ADDENDUM NO.2

Re: **GS# 104-184**
Fant Library Renov. – PH III (Buildout)
Mississippi University for Women
(Institutions of Higher Learning)
Columbus, Mississippi

PROJECT: GS# 104-178
FANT LIBRARY RENOV – PH 3
BUILD OUT
MISSISSIPPI UNIVERSITY FOR WOMEN
COLUMBUS, MISSISSIPPI

Second Floor Plan - Part "A"

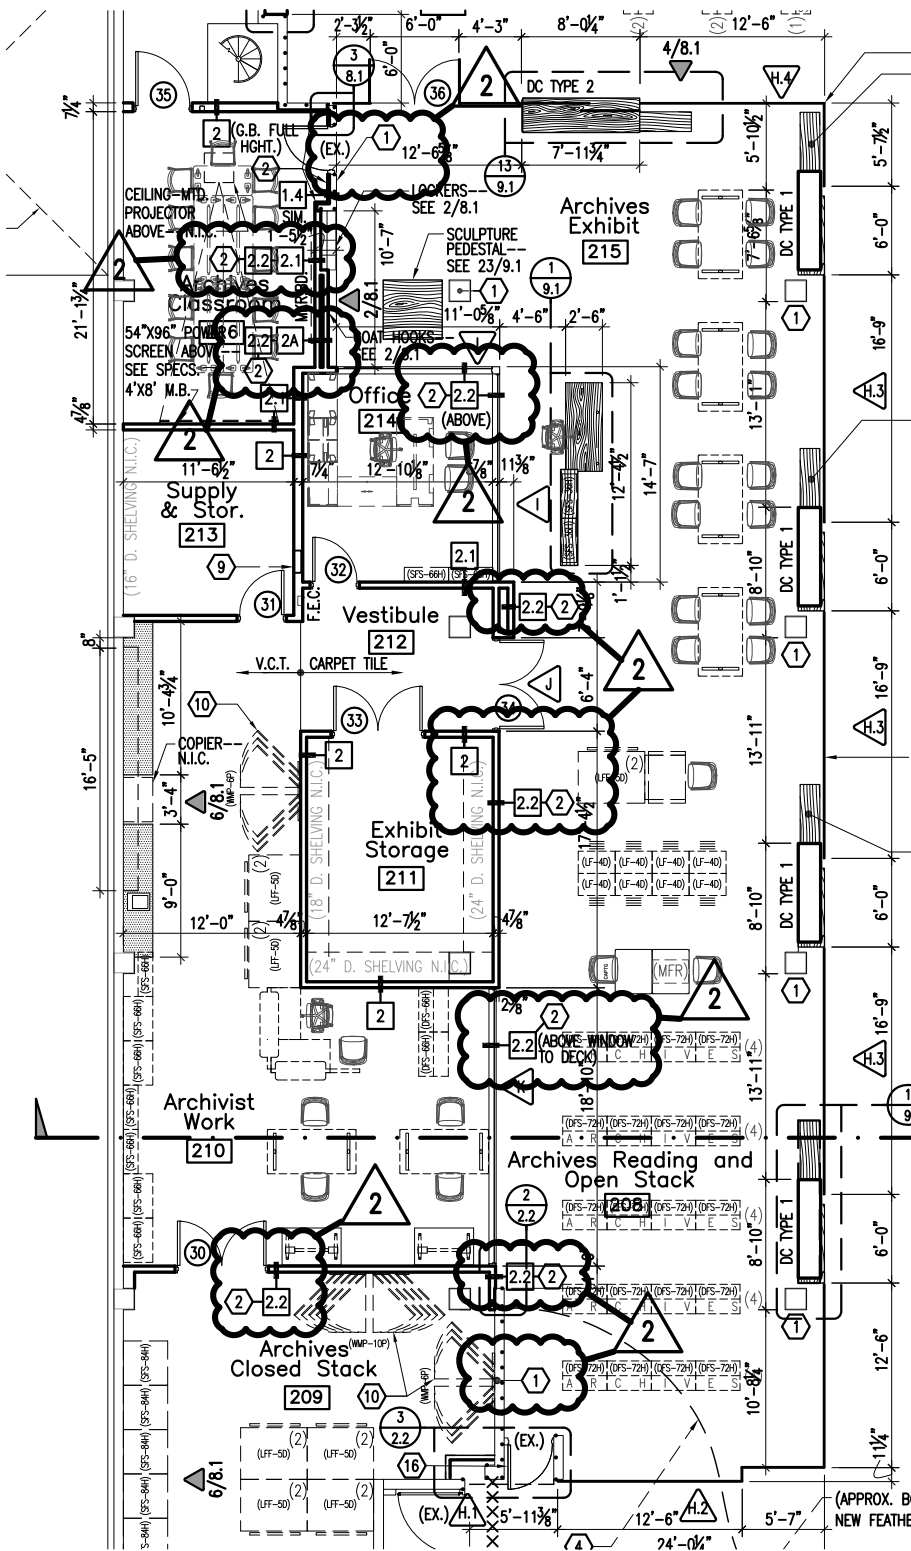
- Item No. 2:** Refer to Sheet 2.2, and change as follows:
- A. Modify Second Floor Plan – Part "A" as shown at attached Exhibit B.
 - B. Modify detail "3" as shown at attached Exhibit "H".

- 1 Provide 3⁵/₈" mtl. stud w/5⁵/₈" g.b. ea. side kneewall (sim. to wall Type 1.4), with R-11 batt insulation, from top exist. cmu wall to deck. Seal.
- 2 Sim. to wall type 2.2, but w/ Owens Corning R-11 EcoTouch Pink Fiberglass Insulation w/kraft facing, in lieu of acoustical batts. Partition to be full-hght., deck to deck.

EXHIBIT "C"

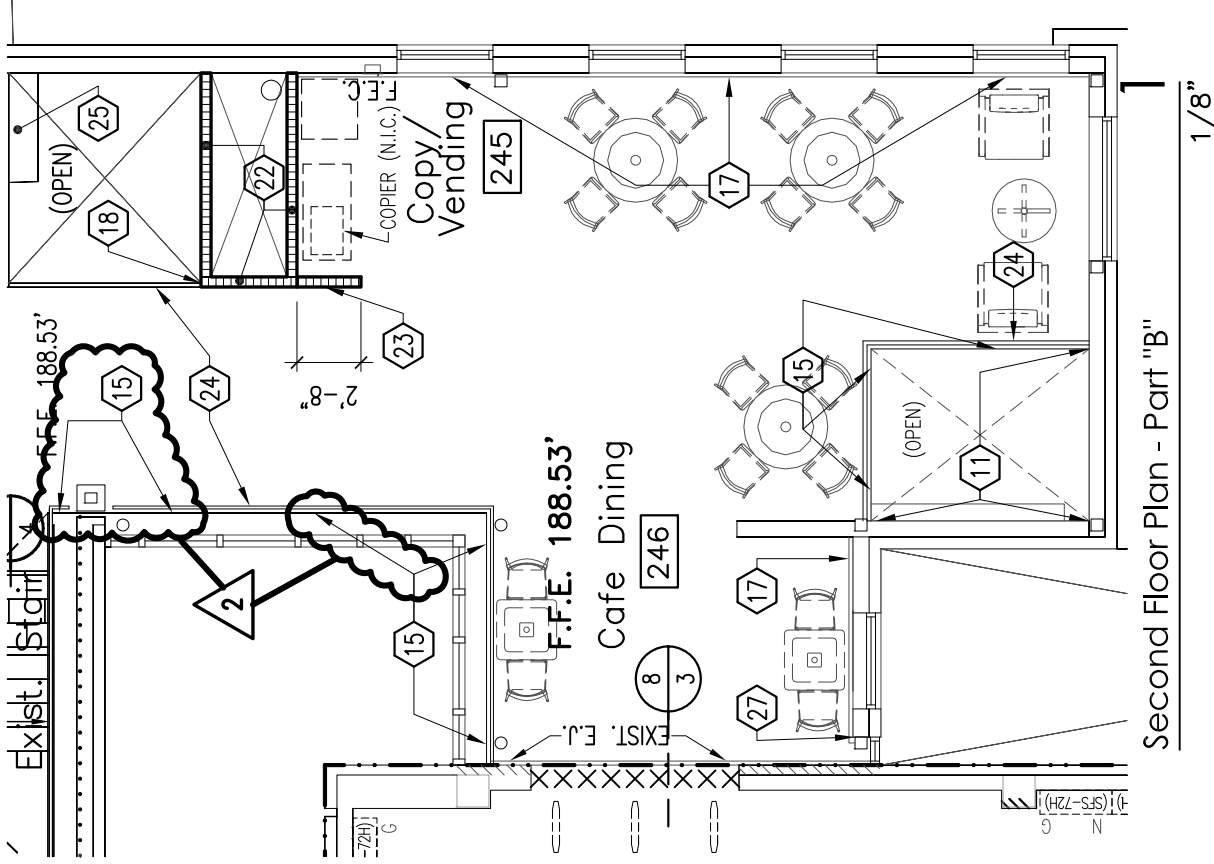
- Item No. 3:** Refer to Sheet 2.3, and modify as shown at attached Exhibit C.
- Item No. 4:** Refer to Sheet 4, Door Schedule and Door Types, and clarify that Door Type F shall be 4'8" wide (to be field-verified with wall layout).

Second Floor RCP - Part "A"

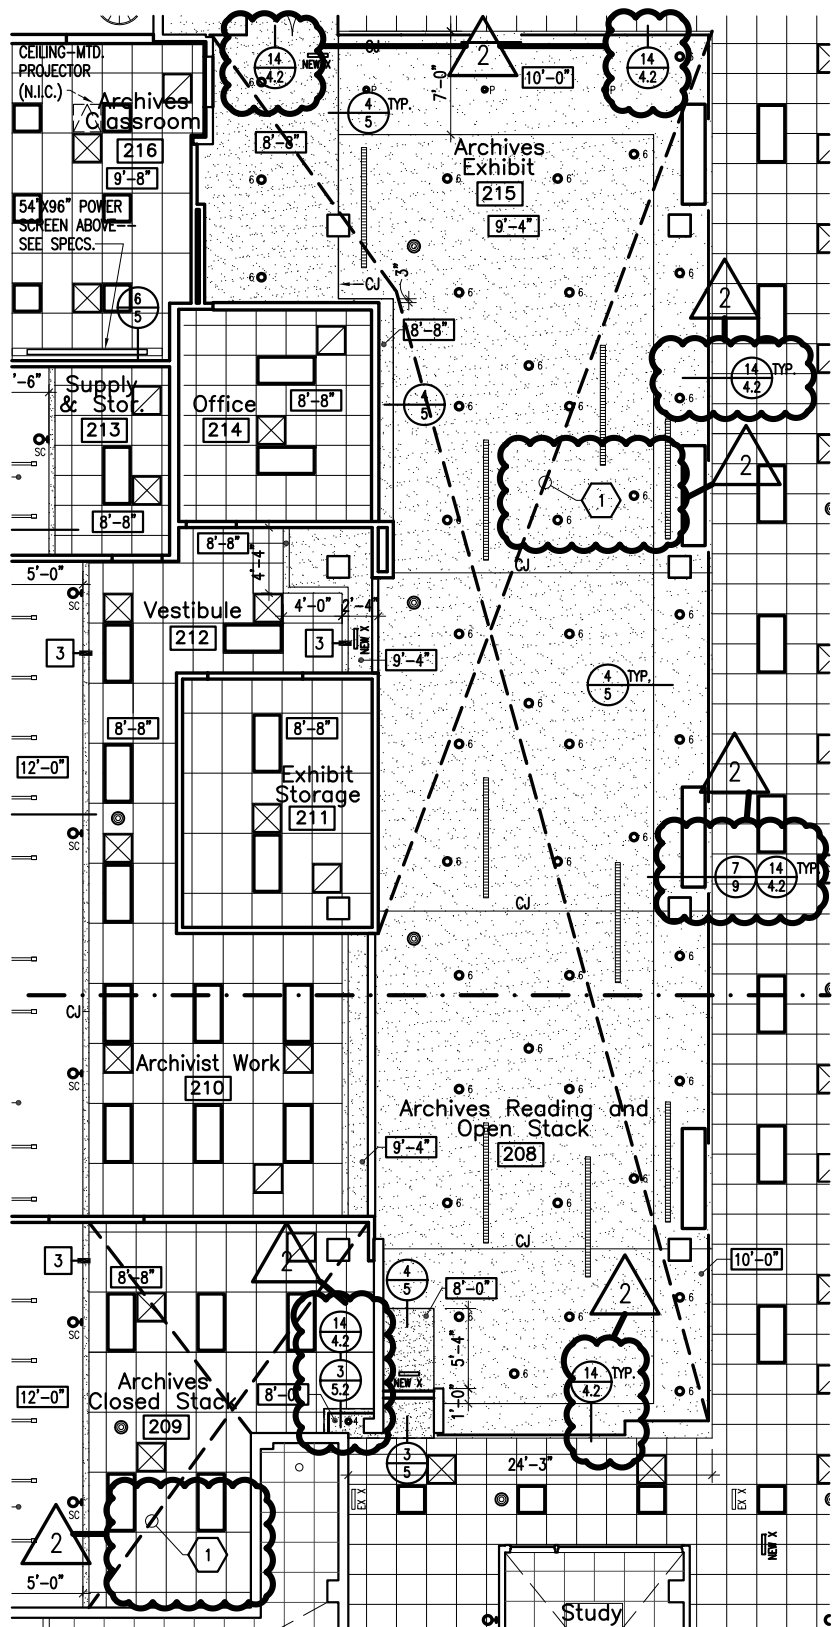
- Item No. 5:** Revise Detail "14" at Sheet 4.2 as shown at attached Exhibit "D".
- Item No. 6:** Refer to Sheet 5.2, and change as follows:
- A. Modify Second Floor RCP – Part "A" as shown at attached Exhibit D

- 1 Provide R-30 batt insul. above clg. these rooms (208, 209, 215), including vertical clerestorey furring @ room 209, equal to Owens-Corning EcoTouch Pink Fiberglass Insul. w/ kraft facing.

REVISED Furring Detail @ E.J.

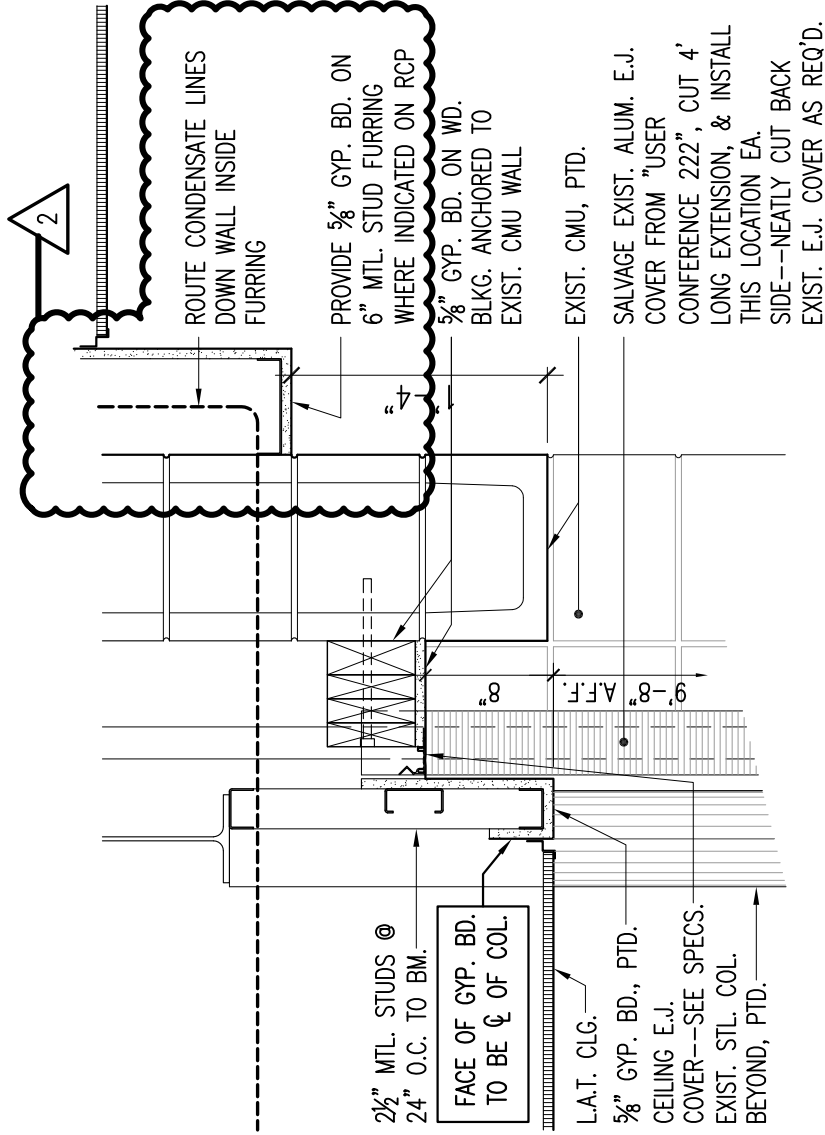
- Item No. 7:** Refer to Sheet 5.3, and change the following:
A. Change RCP as shown at attached Exhibit "E".
B. Modify detail "3" as shown at attached Exhibit "F".

NEW Equipment Rail Detail

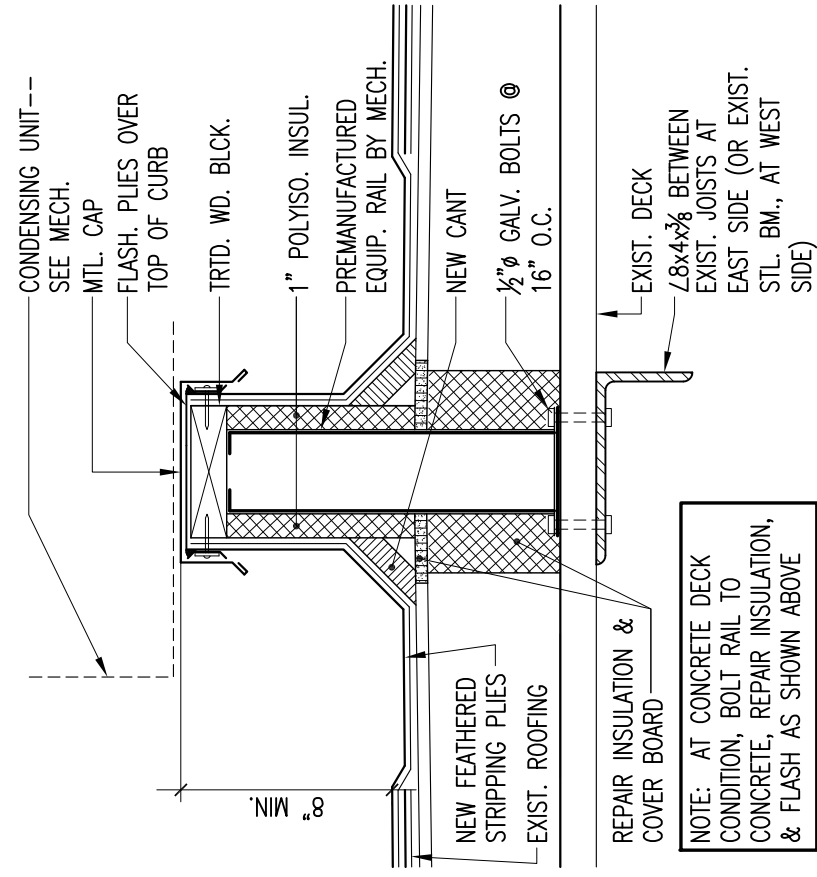
- Item No. 8:** Refer to Sheet 6, and modify roof plan as shown at attached Exhibit "G".
- Item No. 9:** Refer to Sheet 6, and add detail "9", as shown at attached Exhibit "F".

3/8.1
1 1/2"

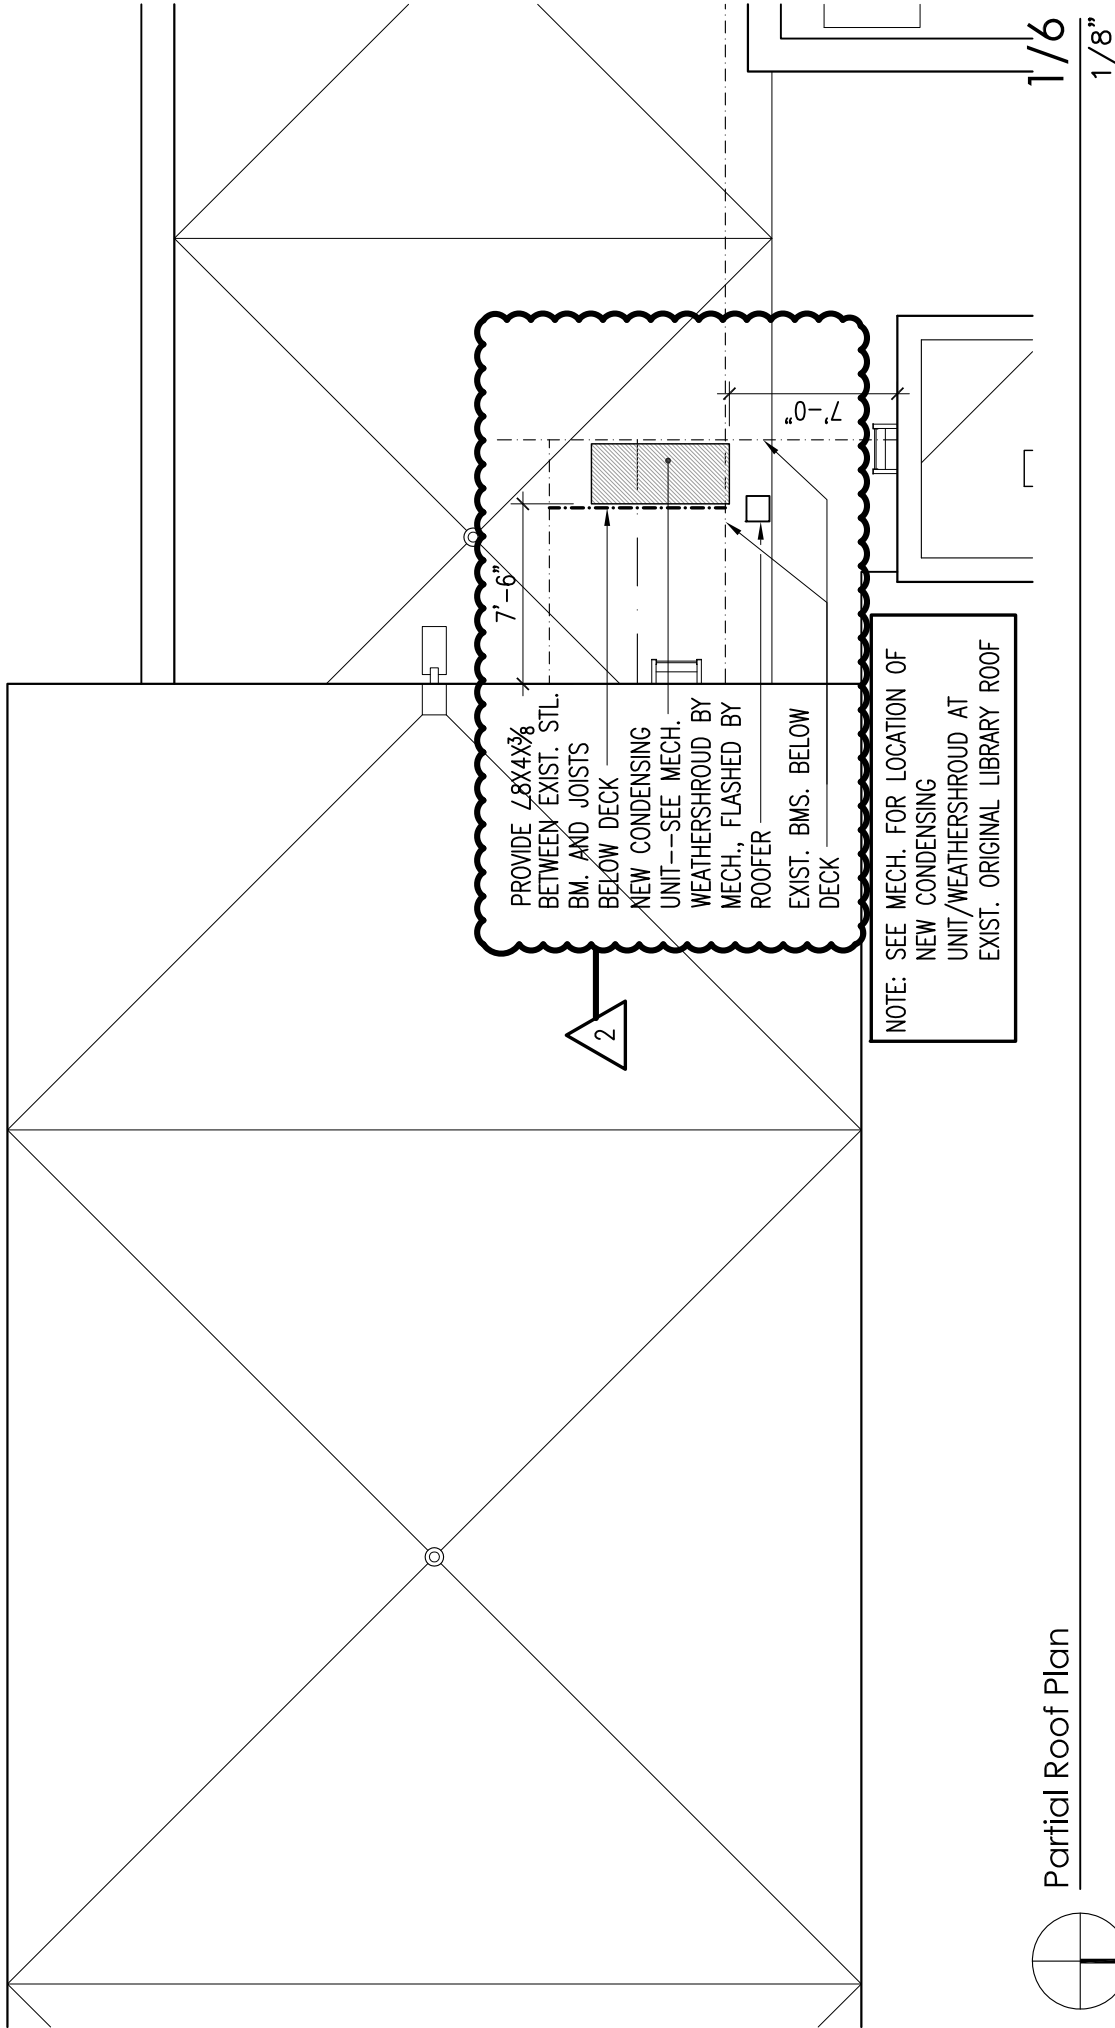
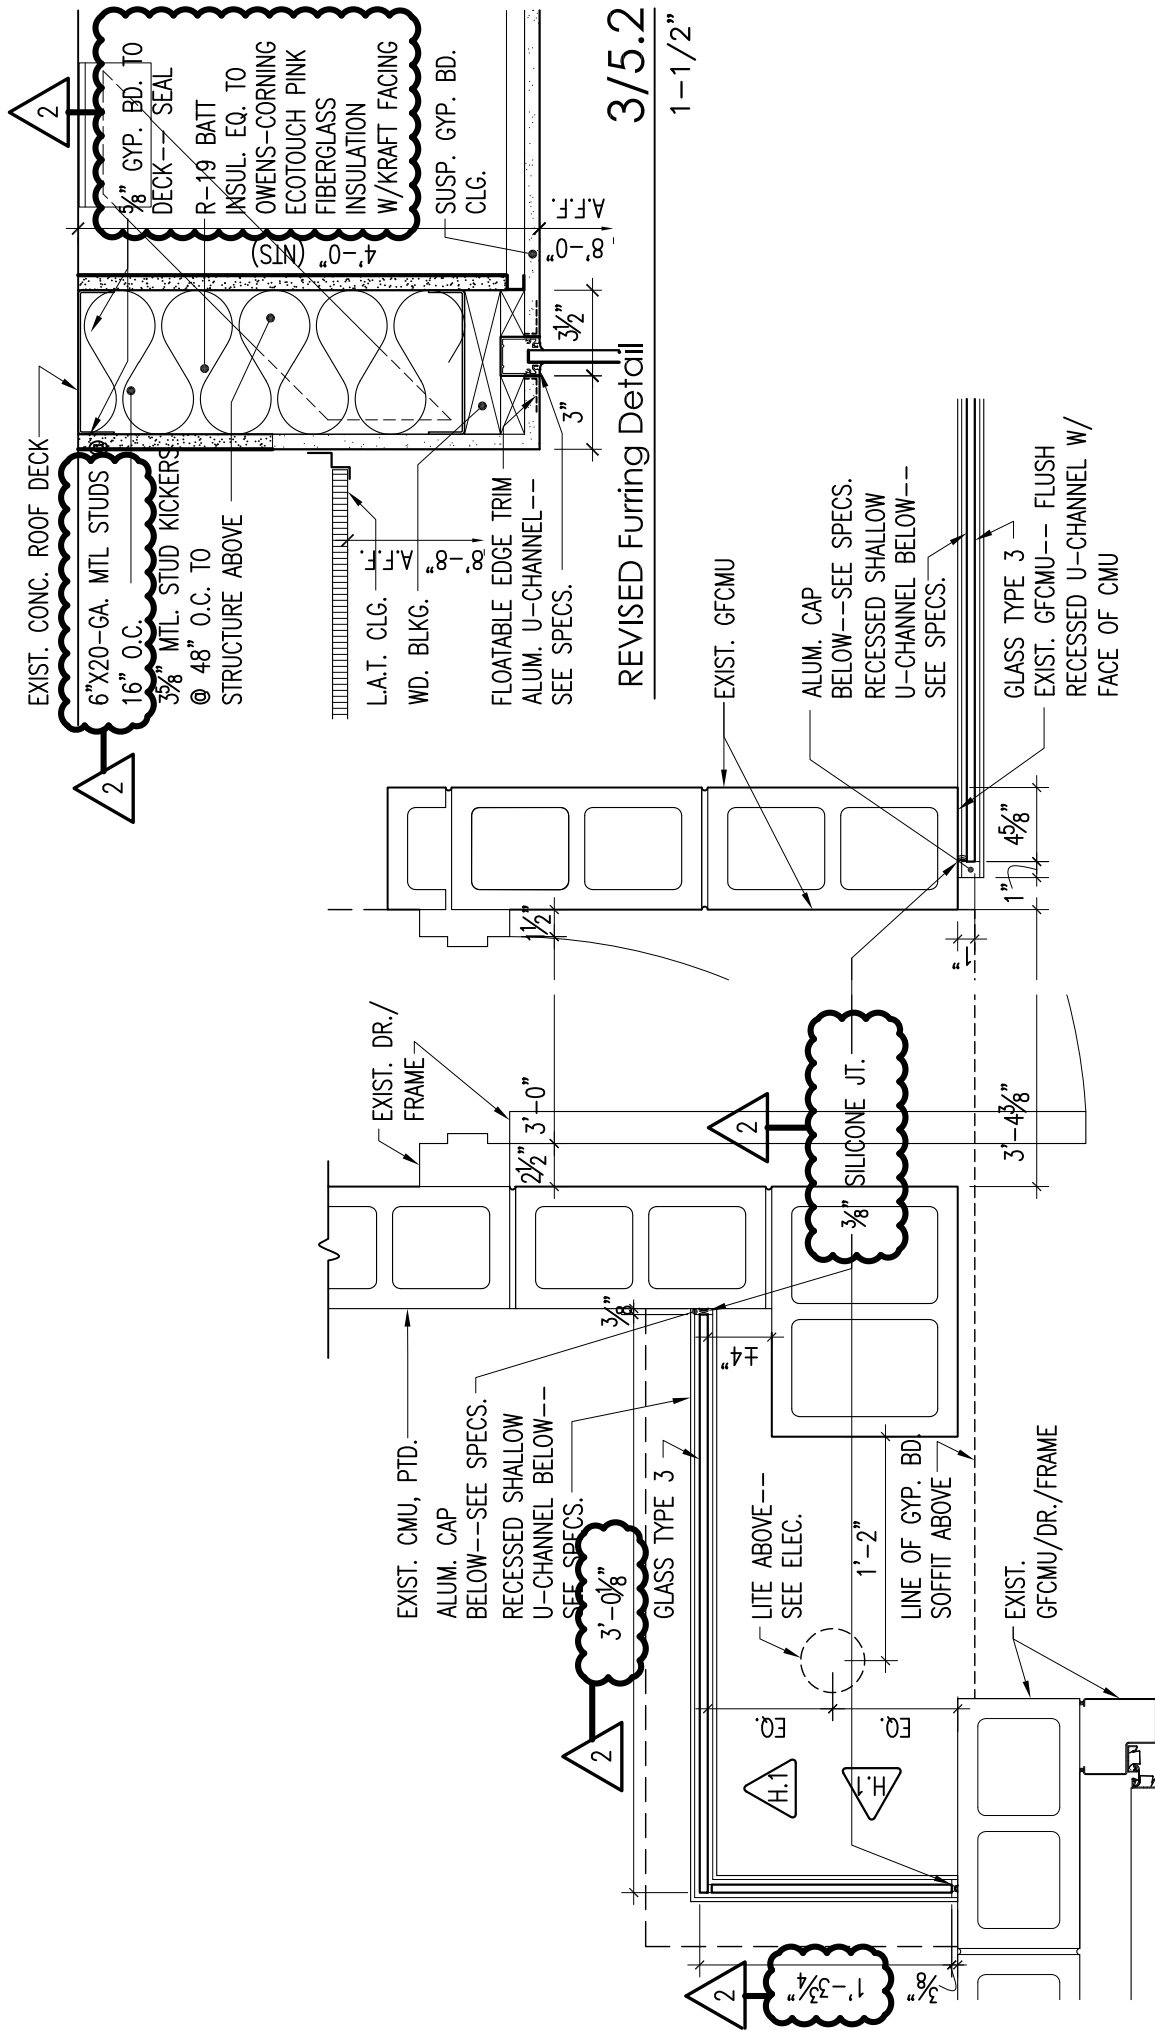
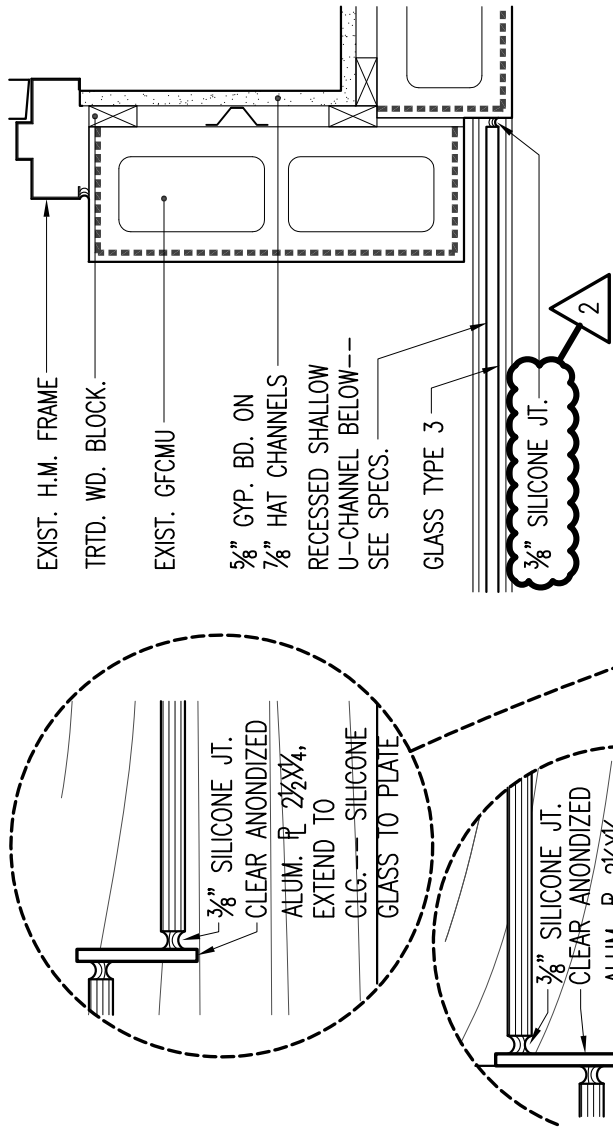
- Item No. 10:** Refer to Sheet 8.1, and change detail "3" as shown at attached Exhibit "I".
- Item No. 11:** Refer to Sheet 9, and change detail "1" as shown at attached Exhibit "J".
